Access Compliance Report Public Rights-of-Way (Curb Ramps)

Main Street: MEANDERING_TRAIL Cross Street: BALMORAL_PL Location: SW

ADA ID: RPRK211019144249 Ramp Type: Type 1 - Perpendicular Diagonal Initial Pass/Fail: Fail Overall Compliance: No Severity Score: 16

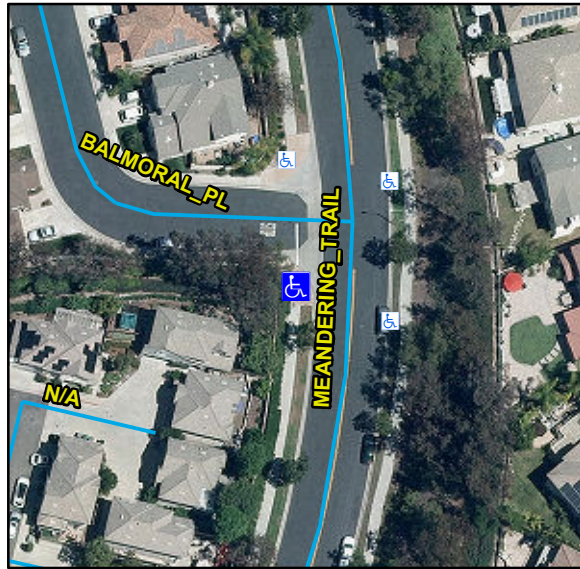
Surveyor Notes:

Remove & Replace Curb Ramp With Two New Directional Ramps or Equivalent.
